Bedroom 1's bathroom · design review F-05 · accept the route (A) or a private bathroom (B)? · Taif / Palm House · A ADOPTED · B NOT ADOPTED: young children's room (owner, V9.0)

OPTION A ADOPTED by the owner (2 Nov 2026): no private bathroom; the wet areas stay grouped in the two clusters; night lights along the route. 2 Nov 2026, after the stair flip (option B, F-b) · bedroom 1 is the north-east room over the maid wing, 15.75 m² on axes, 13.9 m² clear, one room without a bath · nothing in the design files changes until the owner decides · all sizes assumed

bedroom 1 · A · 1 m = 0.95 cm · north up · brown dotted = the ground floor below

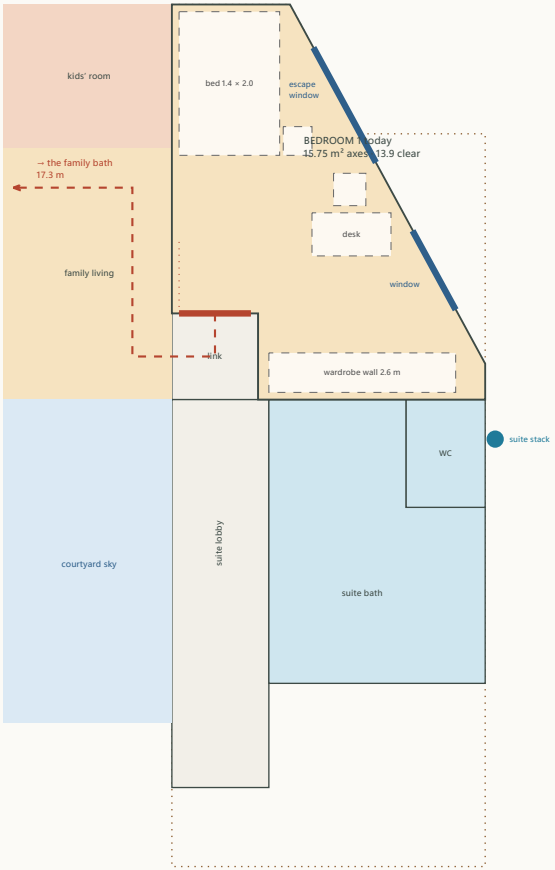
- **The walk, measured after Part 1** (the stair flipped, the family bath enlarged northwards; its door stays at x 4.25, y 9.3–10.3): bedroom 1's door → the family link → the family living, behind the sofa → the gallery's north part, past the stair arrival → the gallery → the bath's door: **17.3 m** (the same as before the flip: the bath grew, its door did not move). Five spaces, two of them lived in (the living, the gallery).

- **Who shares the family bath:** bedroom 1 (17.3 m), bedroom 2 (2.7 m), the kids' room and the family living (a bedroom later); bedroom 3 and the suite have their own. Since F-b it has **two compartments** (a WC by the shaft and the shower + double basin), so two children at once.

- **Comfort:** a child or a guest in bedroom 1 crosses the **family living** at night and in the morning, in sight of whoever is there; 17 m is the longest bathroom walk in the house (the suite's is 0, bedroom 3's 2.7, bedroom 2's 2.7).

bedroom 1 · B2 · 1 m = 0.95 cm · north up · brown dotted = the ground floor below

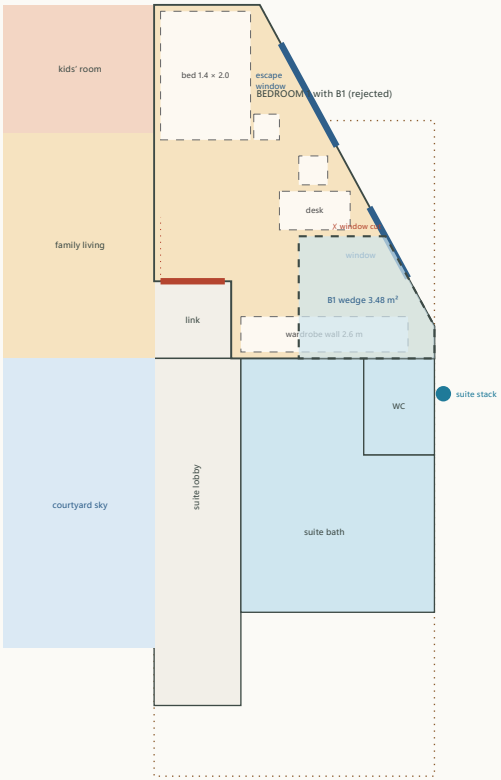
- **B2 (the best, drawn):** a bath along bedroom 1's **south wall**, x 10.6–13.311, y 5.0–6.5, its east end following the cut wall: **3.79 m² on axes, 2.49 × 1.3 clear less the slant ≈ 3.0 m²**: a walk-in shower 0.9 × 1.2 at the east end (its corner 0.02 m west of the cut wall), the WC in the middle facing north, the basin on the west wall, a **sliding 1.0 m door** from the room (no swing), a **small window on the cut wall** (y 5.35–5.85, sill +1.60, obscured). It is **next to the master suite's wet stack**: the pipes run 2.5 m east in the bath's own floor zone to the suite's stack outside the east wall (y 7.05), **over the GF maid room only** (the kitchen and its hood zone start at y 7.0; nothing over the master bedroom).

- **Bedroom 1 with B2: 11.96 m² on axes, ≈ 10.3 m² clear** (was 15.75 / 13.9): the bed 1.4 × 2.0 stays on the west wall with its bedside table, the desk and chair under the escape window, the wardrobe wall (2.6 m) becomes **two wardrobes, 1.3 m on the bath's wall and 0.9 m on the west wall** (2.2 m in all); the door's swing stays clear; the **escape window stays the room's** (the fire study unchanged); the second window (y 4.15–5.25) lights the desk. Still a full bedroom (a 1.4 bed, a desk, 2.2 m of wardrobe), no longer a two-bed room.

- **Drain:** the shower, the WC and the basin to one branch running east along the bath's south side to the **suite's stack** outside the east wall (y 7.05), 2.5 m; the branch crosses the room's south wall line at x 13.311 and turns south outside the wall for 0.6 m (or a second stack beside the suite's; the MEP engineer). **Over the GF maid room only**: not over the kitchen (y ≥ 7.0), its hood zone (the east wall y 10.2–11.2) or the master bedroom (x 8.95–13.311, y 11.9–19.25).

- **Structure (`studies/structure.typ`):** the maid wing's first-floor bay is a **solid 0.20 slab** spanning east–west 4.36 m to the cut wall; a 0.15 depressed zone cannot be cut from 0.20. Two ways, the engineer's choice: **(i)** cast the bay 0.35 thick under the bath with its top depressed 0.15 (as the suite bath, X10), or **(ii)** keep the slab and run the pipes **below** it in the maid room's ceiling void (the maid room gets a gypsum ceiling anyway; 3.1 m clear left) with a wall-hung WC and a shower tray raised ≈ 0.10. The bath's walls are light partitions on the slab (no beam; B6 at y 6.5 is the room's south wall beam, untouched).

- **Windows:** the bath's small window on the cut wall faces the lane side (obscured glass, a vent); the room keeps both its windows. **Ventilation:** the window plus an extract fan to the roof riser is not available here: an extract through the cut wall (a small louvre) or a duct in the ceiling void to the east wall.

Recommendation: B2, if bedroom 1 is to be a guest room or an older child's room; otherwise A

1. **A** (accept the 17.3 m route, no bath) or **B2** (the private bath along the south wall, ≈ 3.0 m² clear, the room 10.3 m² clear)? If B2: the slab detail is the engineer's; the wardrobe split (1.3 + 0.9 m) accepted?

bedroom 1 · B1 · 1 m = 0.95 cm · north up · brown dotted = the ground floor below

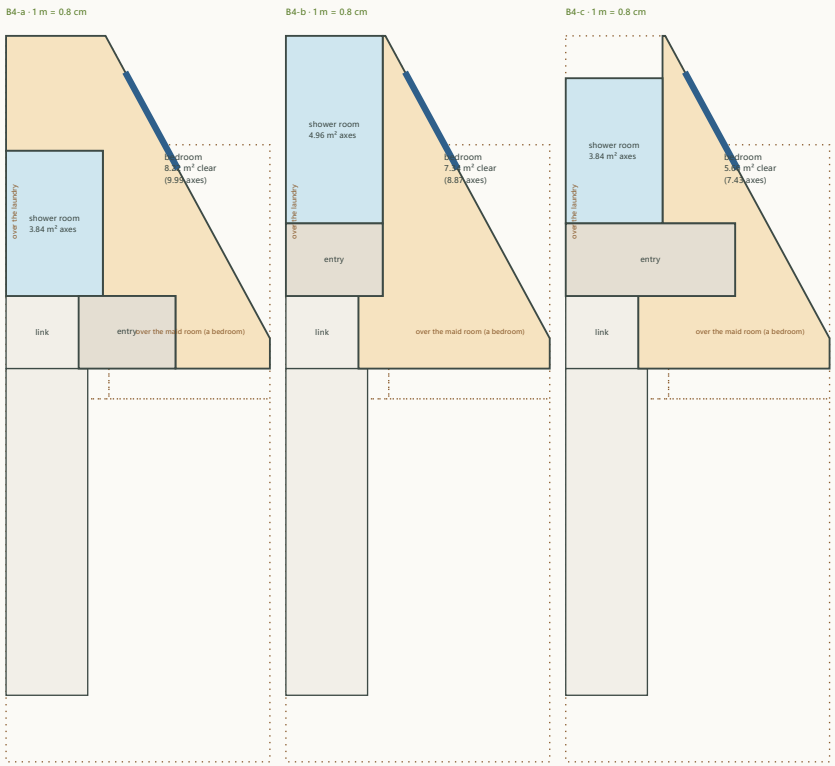
- **B1 (the south-east wedge, dashed on page 2):** x 11.2–13.311 on the cut wall, 3.48 m²: a wedge, its north wall cuts the second window (y 4.15–5.25) and leaves 0.8 m of the wardrobe wall: worse than B2 for the same plumbing. **B3 (the north-east corner):** the north-east corner (x 10.6–12.0, y 1.0–2.9) holds the room's **escape window** and the bed's head wall: a bath there moves the escape window and the bed; rejected without drawing.
